# VICTORIA CROSS

OVER STATION DEVELOPMENT  
NORTH SYDNEY

DETAILED STATE SIGNIFICANT DEVELOPMENT APPLICATION

RESPONSE TO SUBMISSIONS

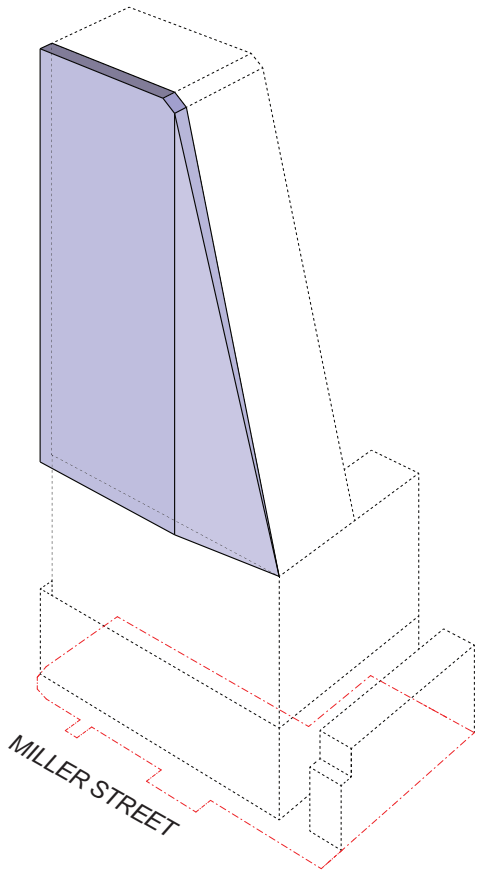
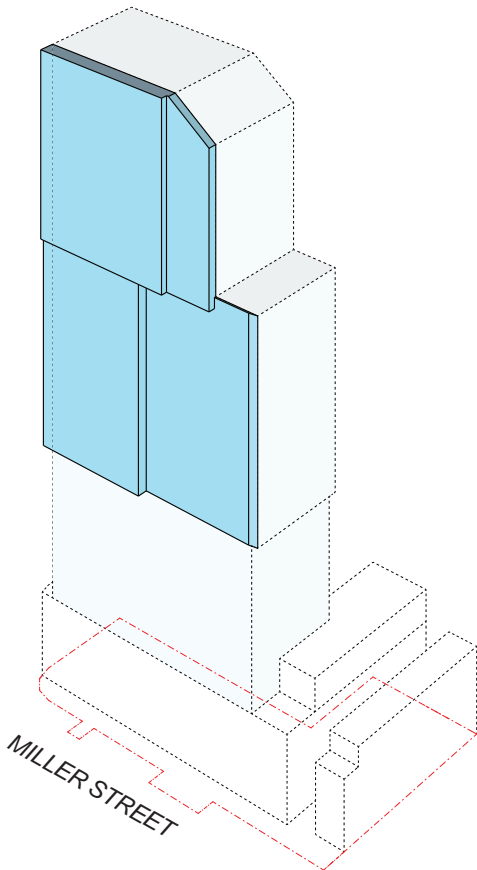
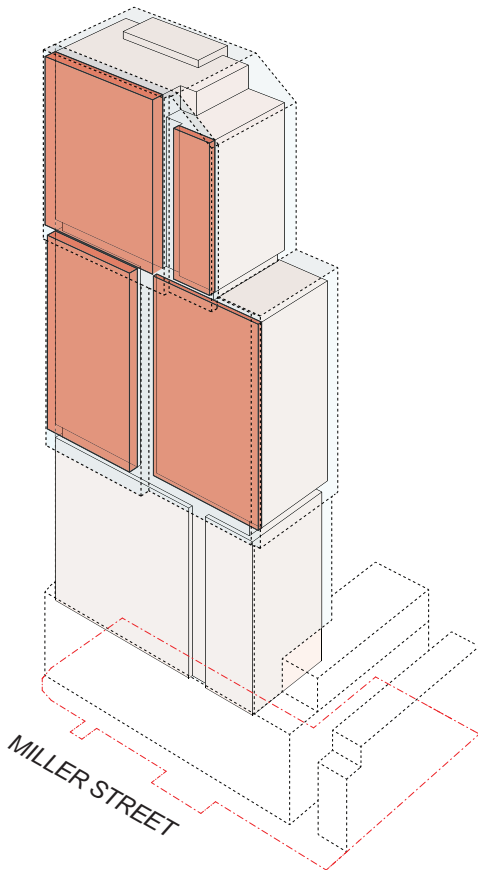
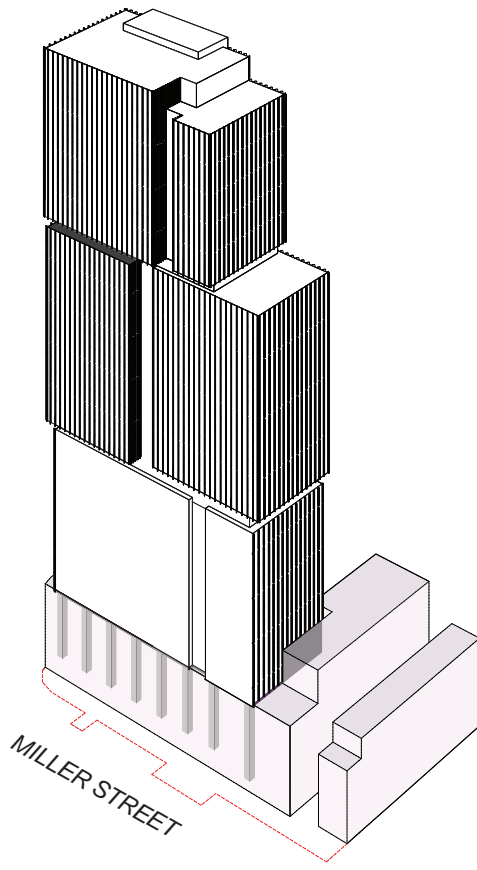
/ THE DESIGN OF THE TOWER WITHIN THE ARTICULATION ZONE AND HOW THE SPECIFIC DESIGN CRITERIA IN THE APPROVED DESIGN GUIDELINES HAVE BEEN ADDRESSED - DPIE

/ THE APPLICATION SHOULD BE AMENDED TO COMPLY ABSOLUTELY WITH THE MILLER STREET SETBACK FOR THE ENTIRETY OF THE FACADE OF THE BUILDING WHICH FACES MILLER STREET. - NORTH SYDNEY COUNCIL

The approved envelope contains an articulation zone of 28,950 cubic metres.

The modified envelope, proposed by Lend Lease, reduces that articulation zone by 9,565 cubic metres to 19,385 cubic metres. The modified envelope articulation zone is not only smaller than the approved articulation zone, but is also wholly contained within it.

The proposed development contains 14,875 cubic metres of building volume within the articulation zone. This represents approximately 77% of the modified envelope articulation zone, and 50% of the approved envelope articulation zone.

The relevant design criteria in the approved Design Guidelines (Clause 5.3, No. 3) states that: The building form within the "articulation zone" of the Miller Street frontage of the building envelope (as illustrated in Figure 5) may utilise some (not all) of the nominated zone.

The built form does not fully occupy the articulation zone it occupies only 50% of the approved envelope articulation zone and 77% of the modified envelope articulation zone.

### BUILDING MASSING

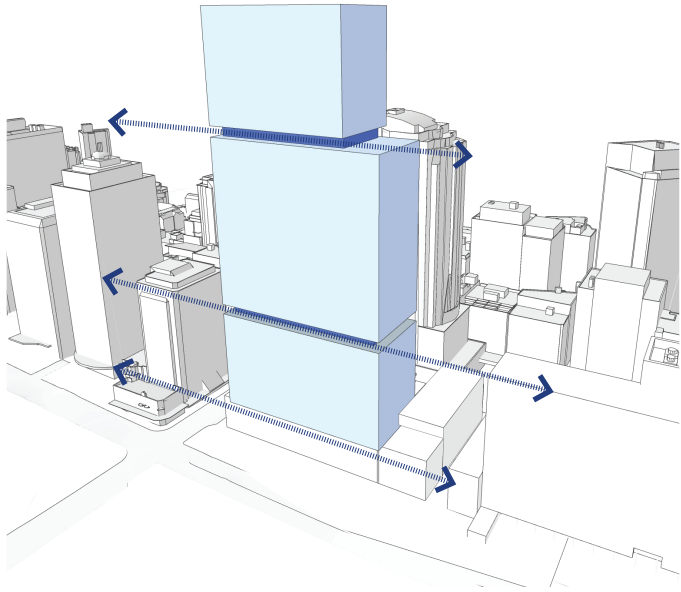
/ THE DESIGN OF THE TOWER WITHIN THE ARTICULATION ZONE AND HOW THE SPECIFIC DESIGN CRITERIA IN THE APPROVED DESIGN GUIDELINES HAVE BEEN ADDRESSED - DPIE

/ THE APPLICATION SHOULD BE AMENDED TO COMPLY ABSOLUTELY WITH THE MILLER STREET SETBACK FOR THE ENTIRETY OF THE FACADE OF THE BUILDING WHICH FACES MILLER STREET. - NORTH SYDNEY COUNCIL

The proposed development has been design to meet the Victoria Cross Design Guidelines, May 2019, 5.3 Building Design, No. 3, parts a to d, as follows:

/ The proposed massing is fully in compliance with overshadowing requirements of NSLEP 2013

/ The proposed massing respects the datum and scale of the adjoining MLC building by incorporating a horizontal recessed articulation, and a variation in façade depth, aligning with the scale of the adjacent heritage building, while also faithfully acknowledging the minor gradient within the streetscape.

/ The proposed massing maintains sky view through providing varying articulation depth based on height. There is no cantilever below level 15. Between levels 16 and 29, the cantilever ranges between 0.0m to 3.0m. The maximum cantilever of 3.9m occurs above level 30. Due to the human eye perceiving objects more distant as being smaller than objects nearby, this configuration creates negligible impact on skyplane, as opposed to, say, larger cantilevers at lower levels and no cantilevers on upper levels. Sky view is also vastly improved in the proposed development as compared to the approved envelope due to the removal of 14 storeys of commercial space located above the northern side of the laneway.

/ The massing in the articulation zone is responsible for reducing downdrafts from the western tower face, causing wind paths to be broken up before they reach ground level. The Pedestrian Wind report (refer appendices and extract provided) demonstrates that wind conditions at the base of the tower in the Miller Street public domain, beneath the articulation zone, are the lowest and most comfortable in the entire precinct.

INDIVIDUAL FINS PROJECTING BEYOND ENVELOPE

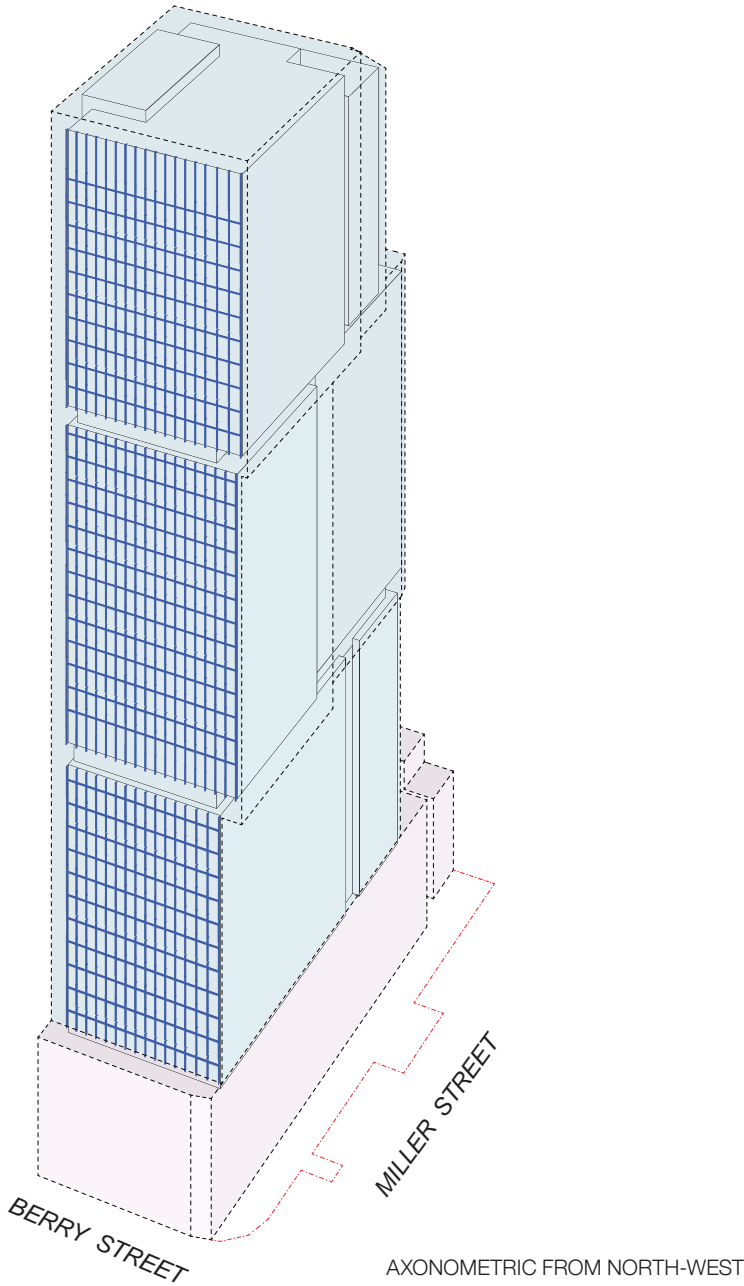
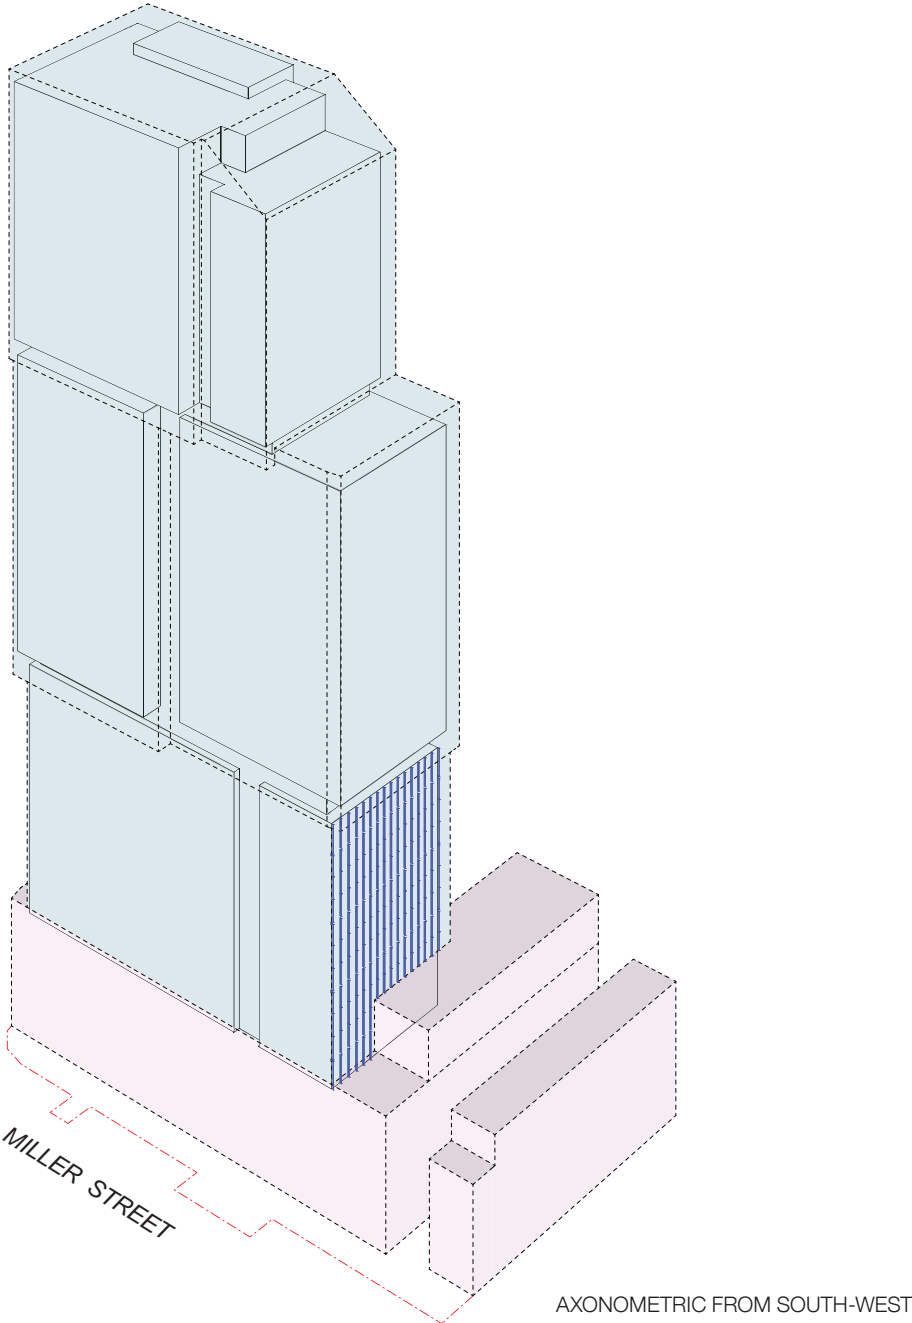
/ CONDITION A15 WHICH REQUIRES THE BUILDING NOT TO EXCEED THE APPROVED BUILDING ENVELOPE. - DPIE

The adjacent diagrams show compliance of the proposed development with current condition A15:

/ All proposed built form, apart from the below exception is wholly contained within the modified envelope.

/ The only element of built form projecting beyond the modified envelope is the external sun shading (illustrated in dark blue in the following built form studies) on the north façade (projecting 490mm beyond the envelope), and external shading on low rise floors facing south, (projecting 100mm beyond the envelope.)

The modified envelope drawings reflect this exemption on both the north and south sides of the envelope.

AXONOMETRIC FROM NORTH-EAST

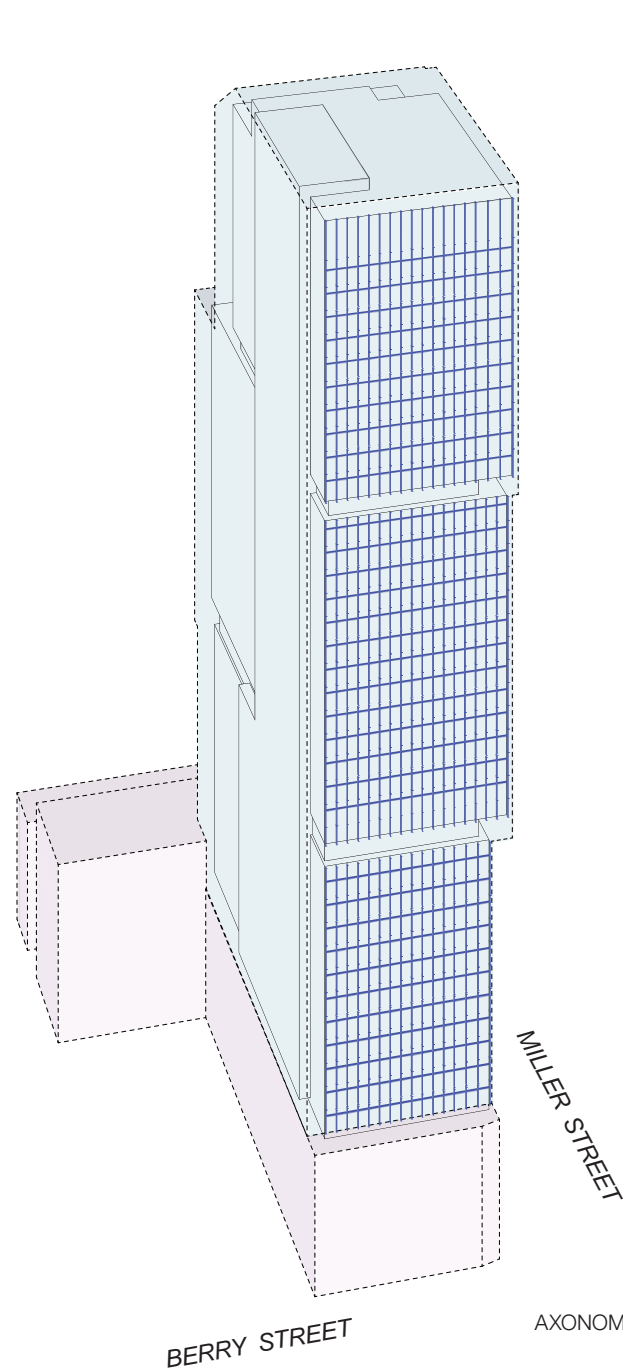
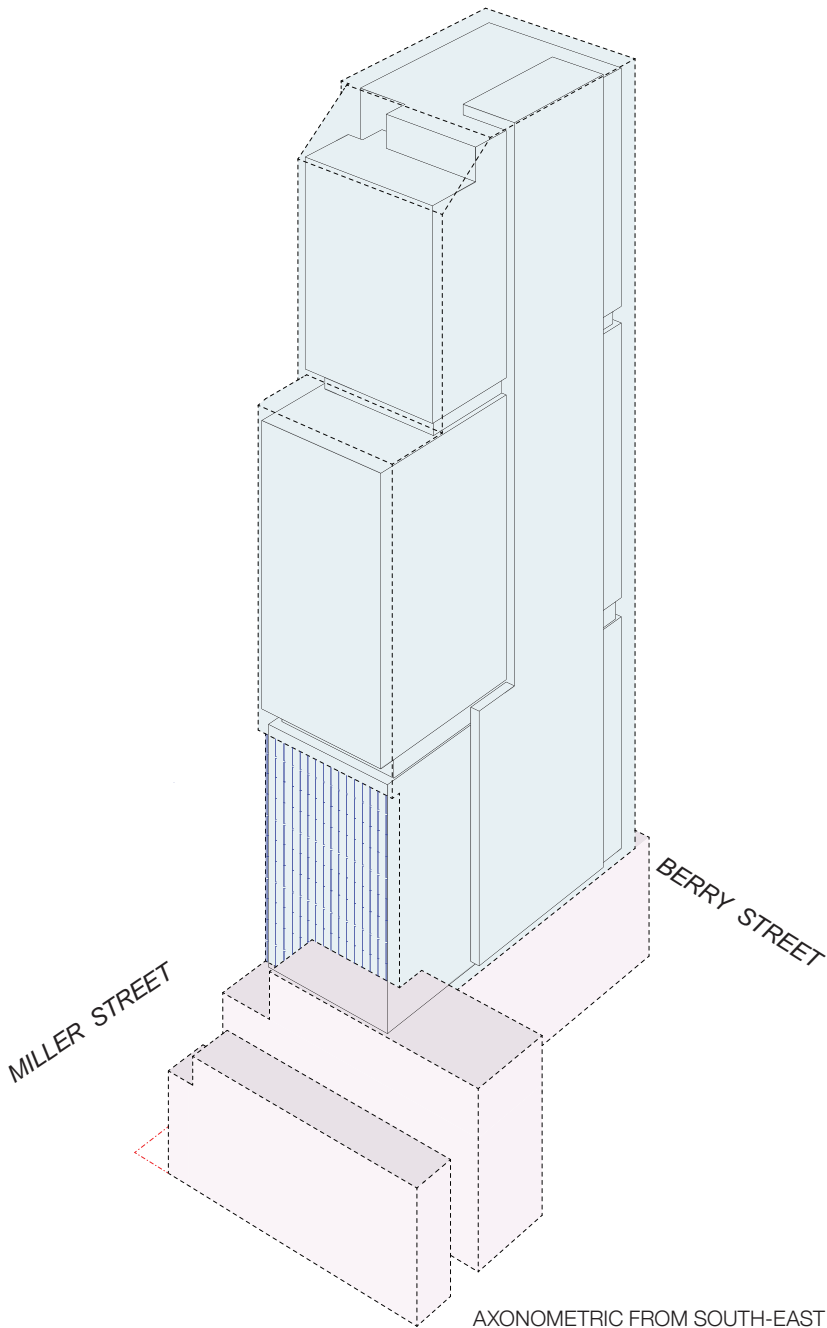
/ CONDITION A15 WHICH REQUIRES THE BUILDING NOT TO EXCEED THE APPROVED BUILDING ENVELOPE. - DPIE

## VIEW ANALYSIS ALEXANDER APARTMENTS

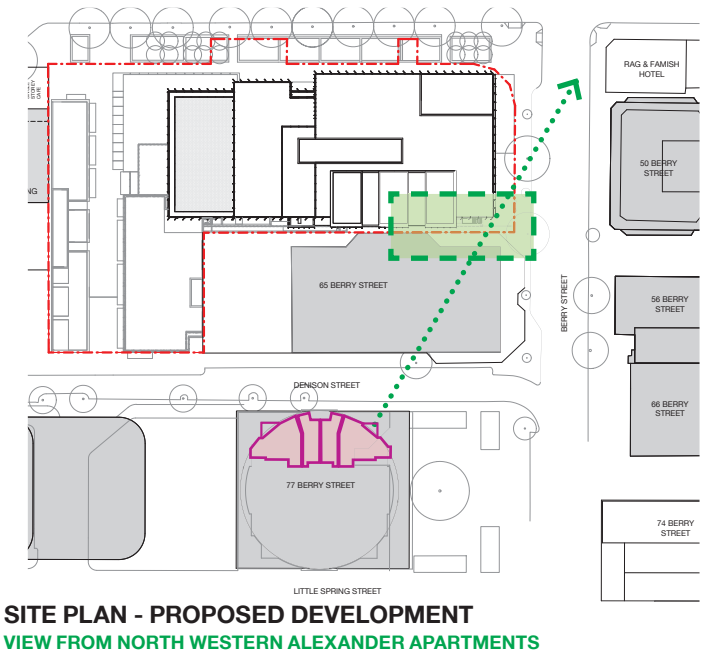
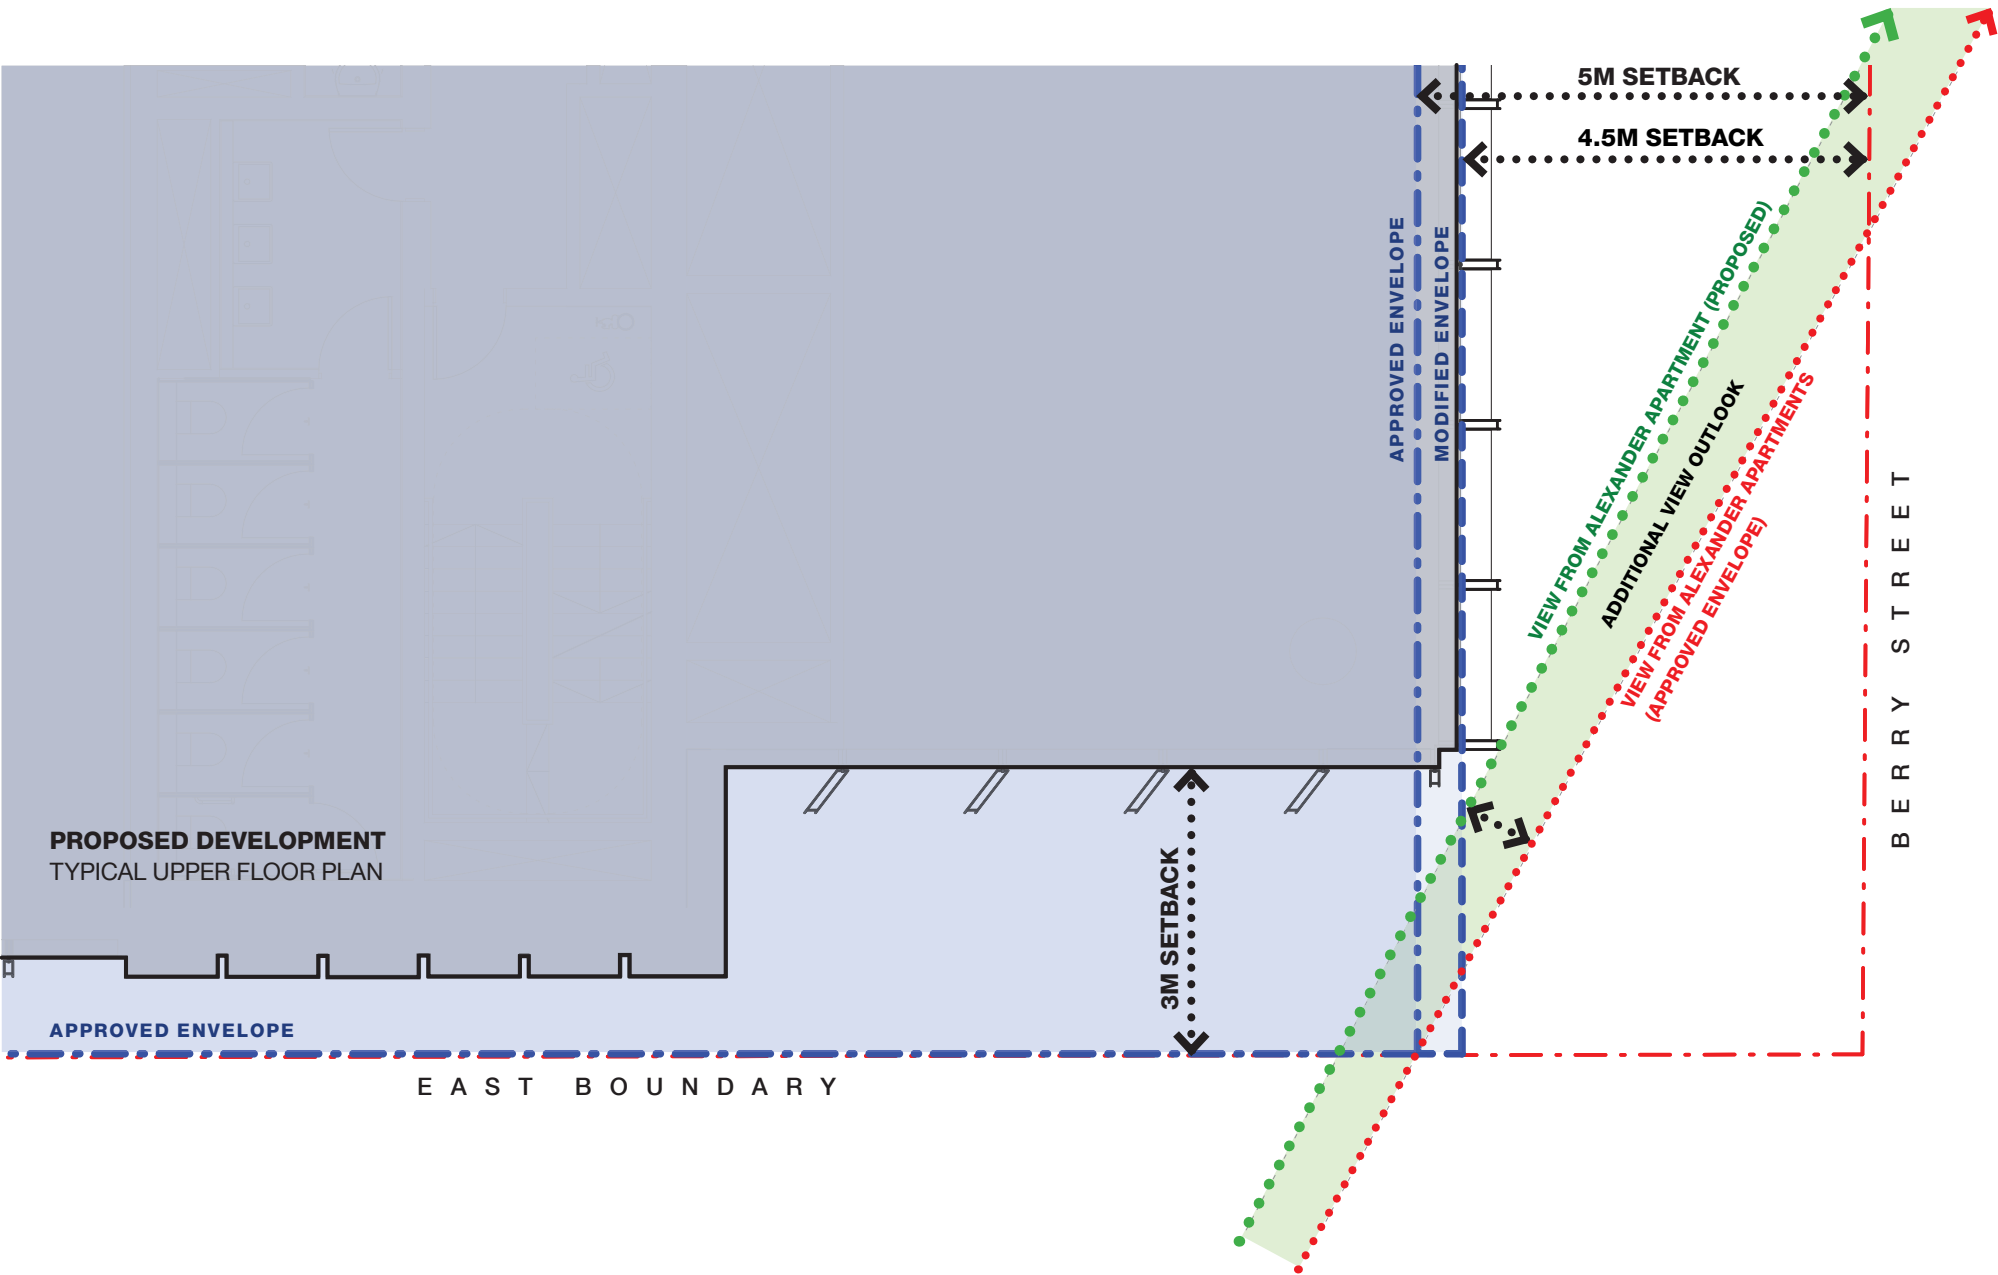
/ THE PROPOSED MODIFICATIONS TO THE BUILDING ENVELOPE AND DISTRIBUTION  
OF MASSING IN RELATION TO THE VIEW LOSS AND AMENITY CONCERNS RAISED IN PUBLIC SUBMISSIONS - DPIE

The approved building envelope has a zero metre setback to the eastern boundary and a 5m setback to the northern boundary (Berry Street).

While the proposed modification to the building envelope reduces the approved setback from the northern boundary (Berry Street) from 5m to 4.5m plus shading structures, the proposed detailed development provides an additional 3m setback to the eastern boundary in the north eastern corner of the site. The inclusion of this setback to the eastern boundary creates an additional view corridor from the Alexander Apartments to the north west, compared to the approved building envelope.

As illustrated in the adjacent plan, the reduction of the northern setback by 0.5m and the inclusion of additional shading elements outside of the building envelope maintains an additional view corridor to the Alexandria Apartments compared to the approved building envelope. Further, the additional 3m setback to the eastern boundary improves solar access and general outlook from the Alexandria Apartments compared to the approved building envelope, notwithstanding the proposed changes to the approved building envelope, as evidenced in the view impact studies and shadow analysis included within this response.
